SUBJECT: James A. FitzPatrick Nuclear Power Plant
Docket No. 50-333
**Request for Additional Information -
Proposed Changes to the Technical Specifications
Spent Fuel Pool Storage Capacity (JPTS 90-035)**

**RESPONSE TO NRC REQUEST 2 FOR ADDITIONAL INFORMATION
SPENT FUEL POOL STORAGE CAPACITY INCREASE**

HOLTEC REPORT HI-91614
DYNARACK SIMULATIONS TO DEMONSTRATE THE ABILITY
TO PREDICT CLASSICAL NONLINEAR PHENOMENA

FIGURE 2.10

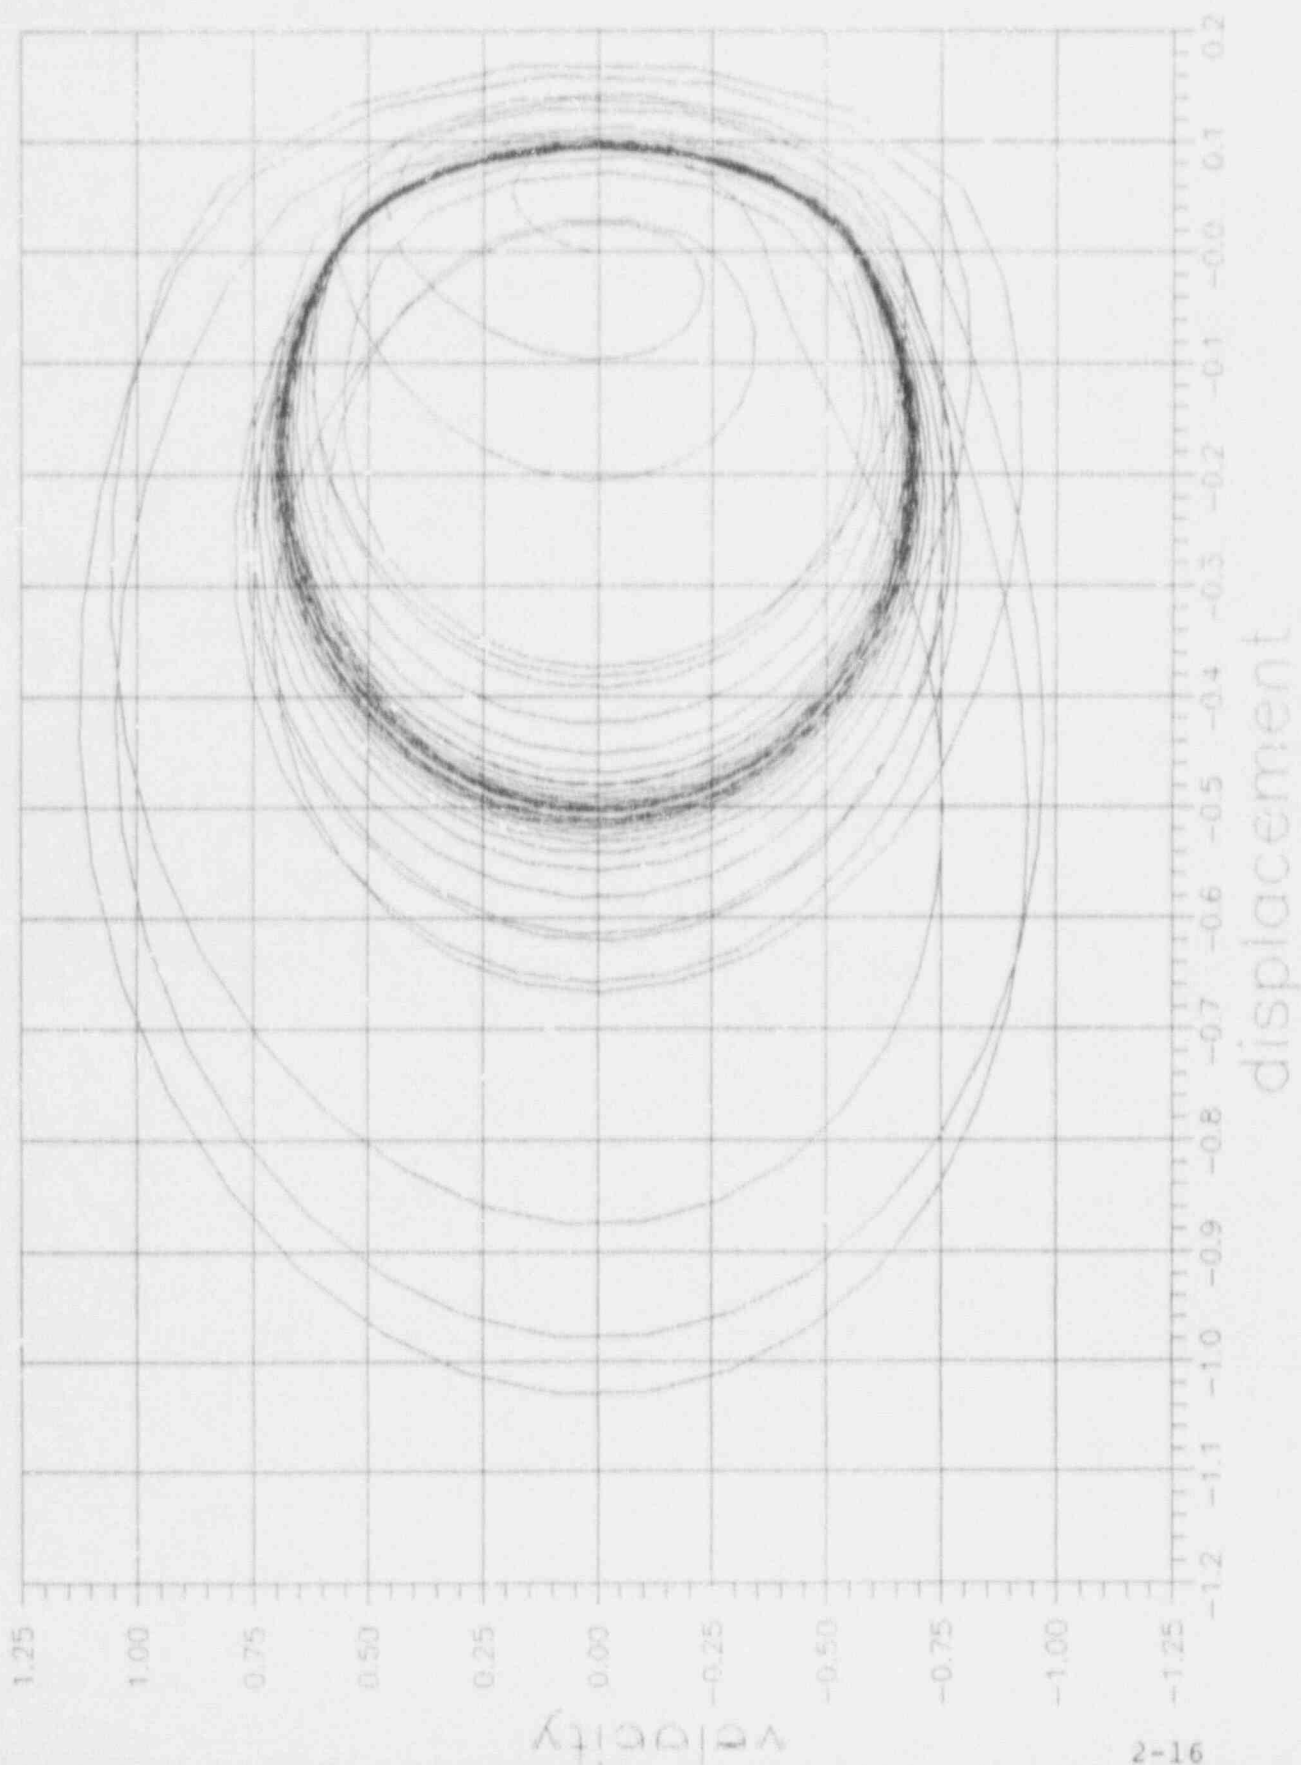
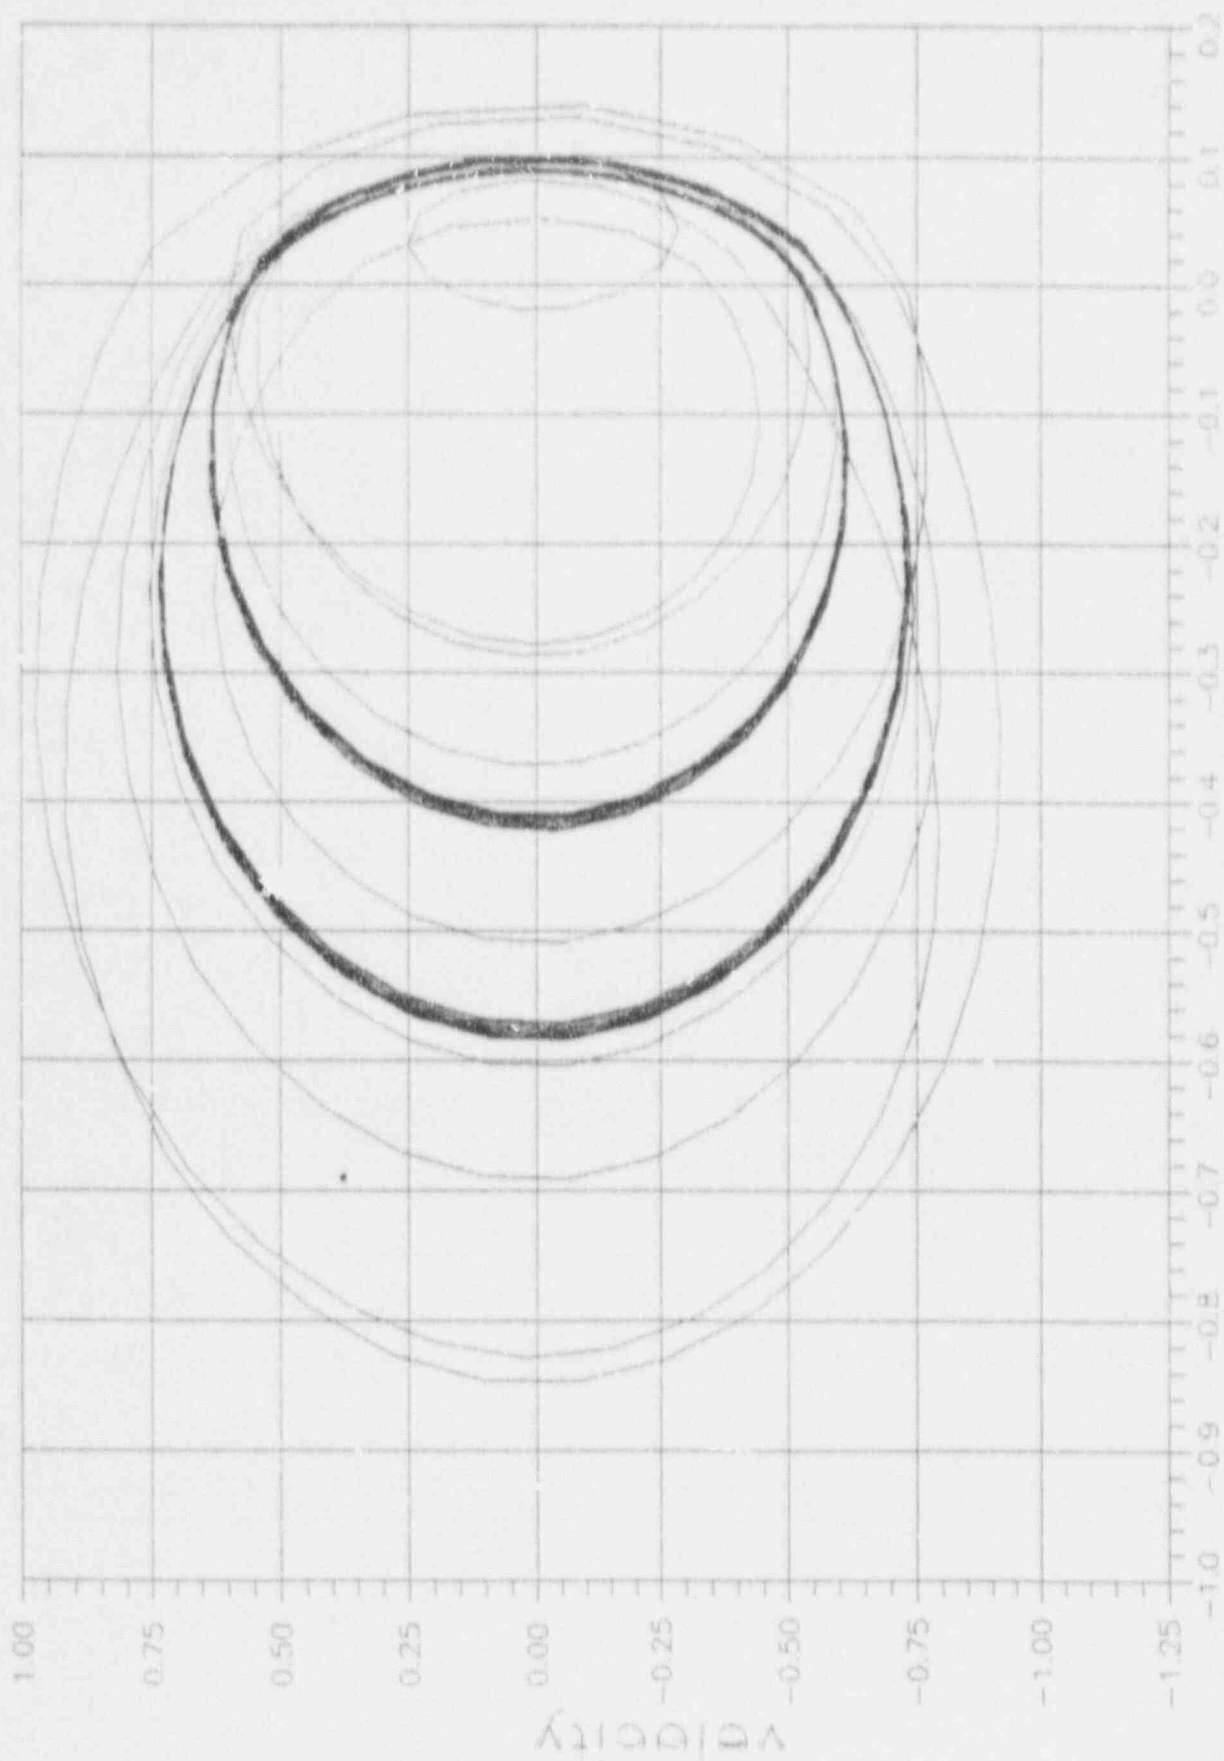
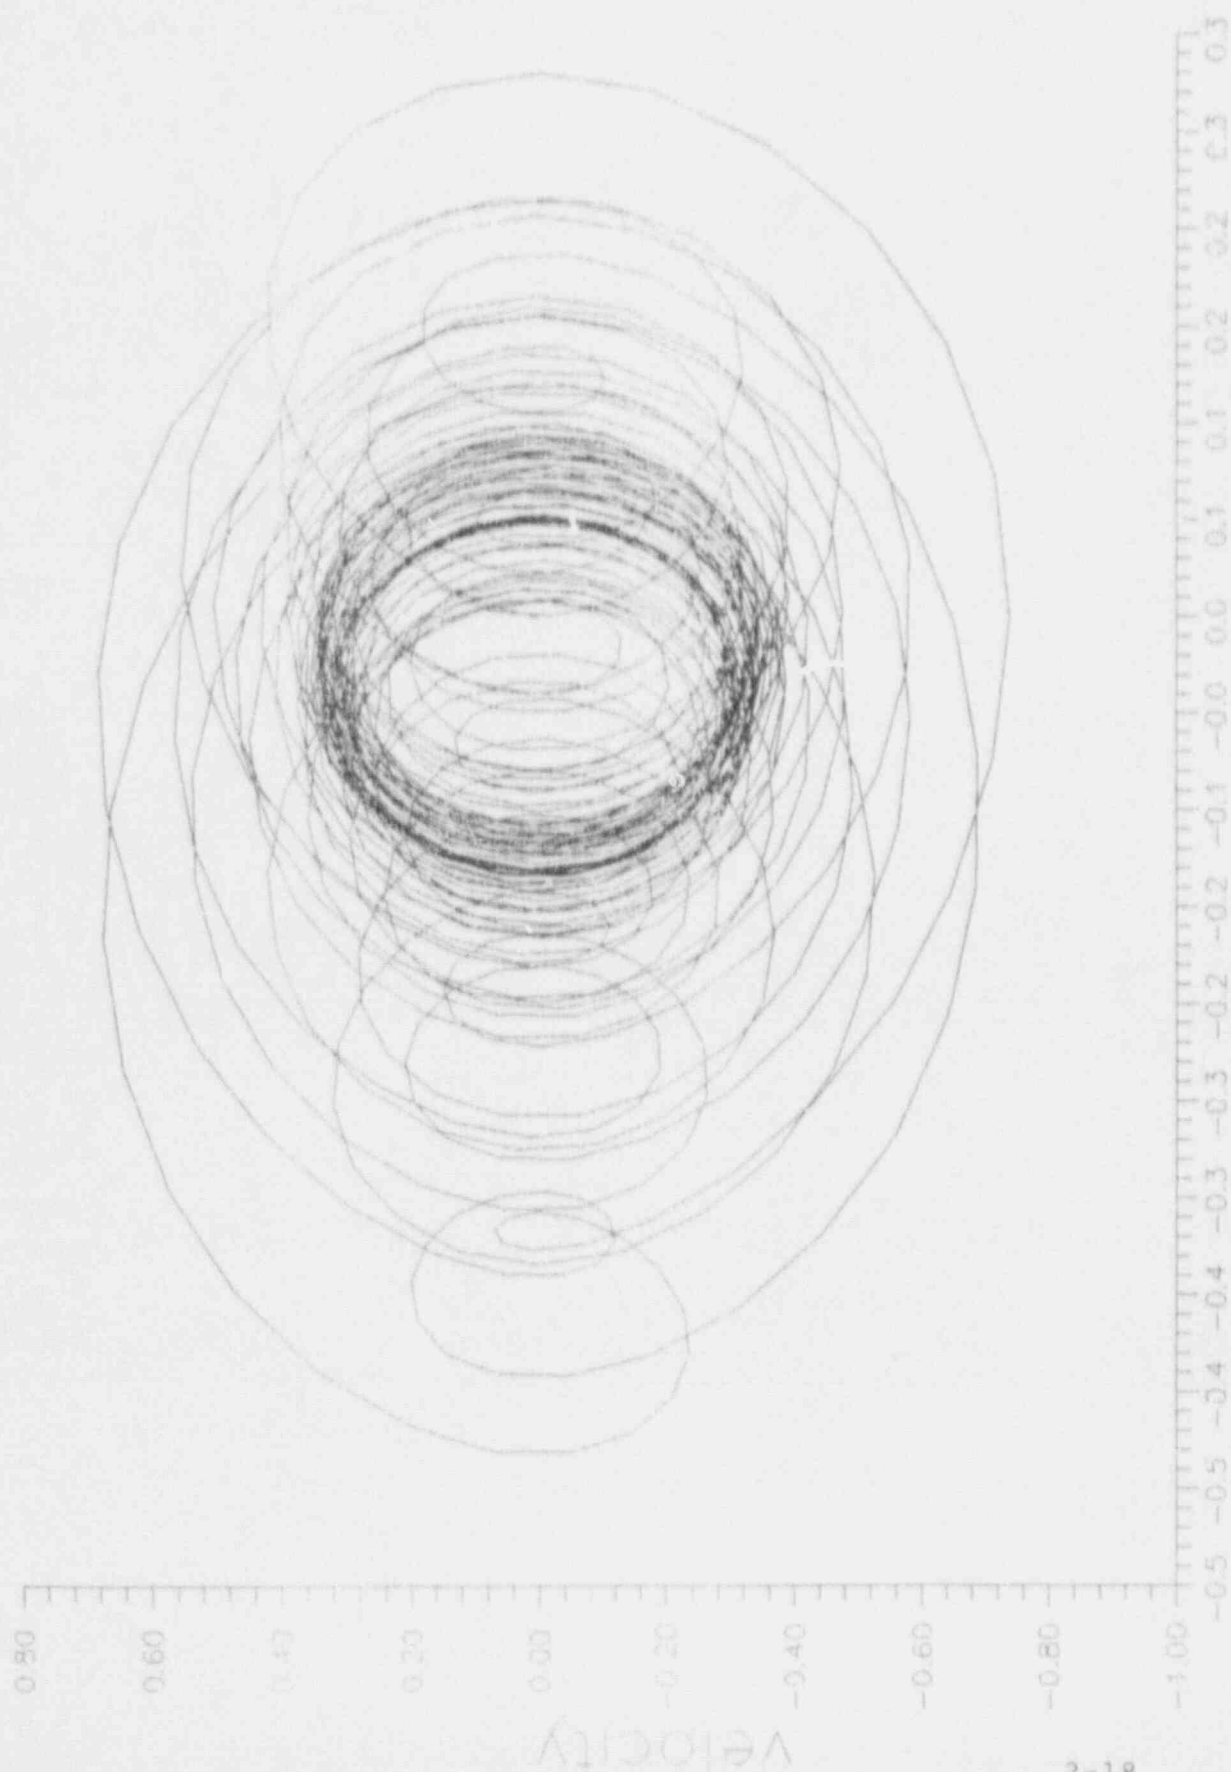
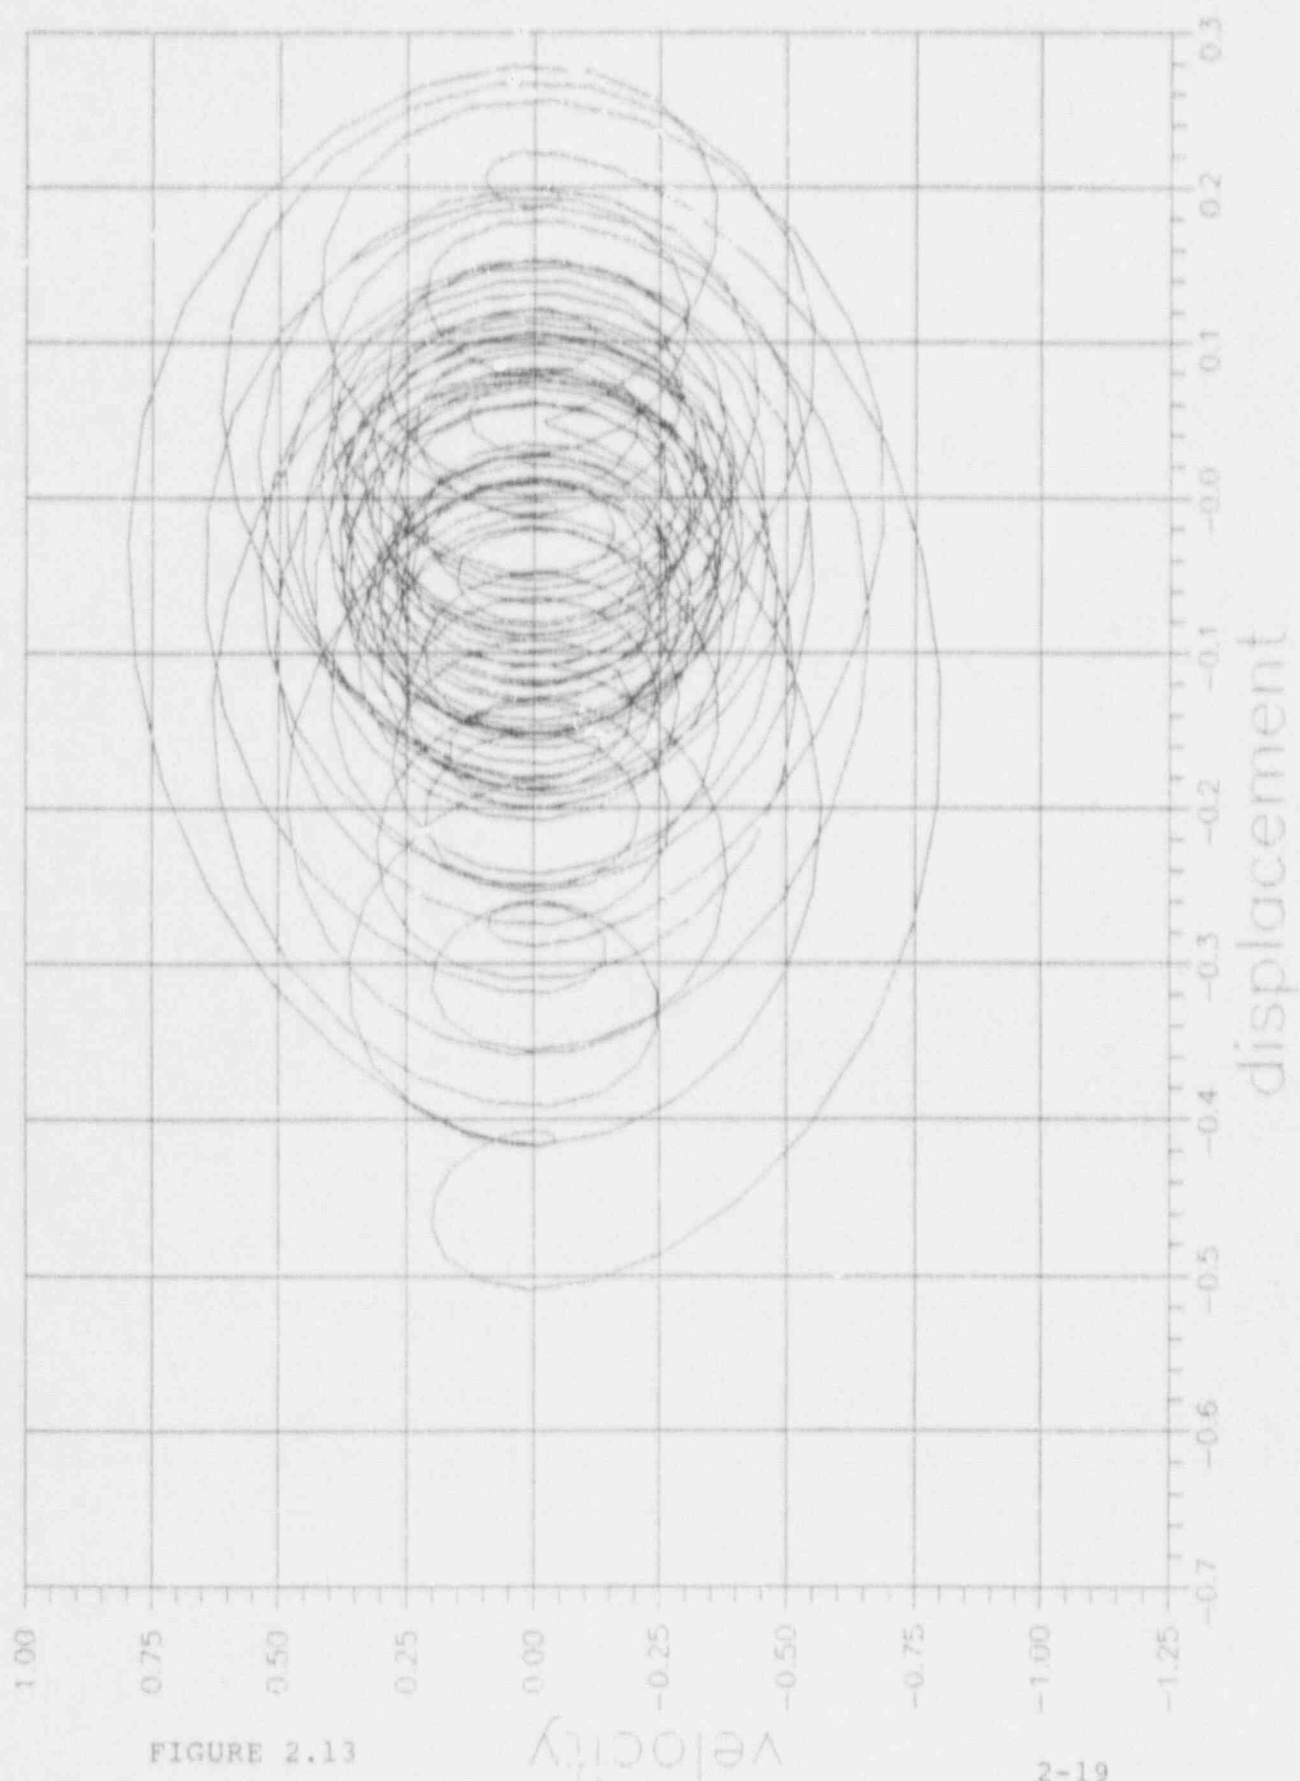
P. 6-15. It is stated that a central difference scheme is used for solution of the governing differential equations. Demonstrate how such a scheme can adequately depict various response phenomena, such as, subharmonic, bifurcation, and instability associated with nonlinear dynamics. Provide a specific example for such demonstration similar to that provided in references (1) and (2). Discuss how error associated with numerical integration is assessed and accounted for in a similar manner as that of reference (3). Also provide verification of the computer results with available experimental data.

The results from DYNARACK, for the same problems of Figure 2.9, are shown in Figures 2.10 - 2.14. The computer simulation started from a specified initial condition and covered a sufficient number of cycles so that a limit cycle could be established. Figures 2.10 and 2.11 show the match with two problems shown in Figure 2.9. The simulation predicts the one or two stable limit cycles. Figures 2.12 - 2.14 show results of the similar analysis for the third case considered. Figures 2.12 and 2.13 show the effect of different starting conditions. It is clear that only the stable period one orbit is being tracked by the numerical solution. Figure 2.14 is a plot of only the last few hundred time steps and confirms the tendency toward the stable period one orbit. The period three orbit appears unstable which seems to contradict the conclusion in Shaw and Holmes. However, if one reads the text in Figure 2.9, Shaw and Holmes appear to conclude that an unstable period three also exists at the same parameter values. We can only conclude that it is extremely fortuitous if the numerical solution can simulate a stable orbit when an unstable orbit with the same period exists concurrently.
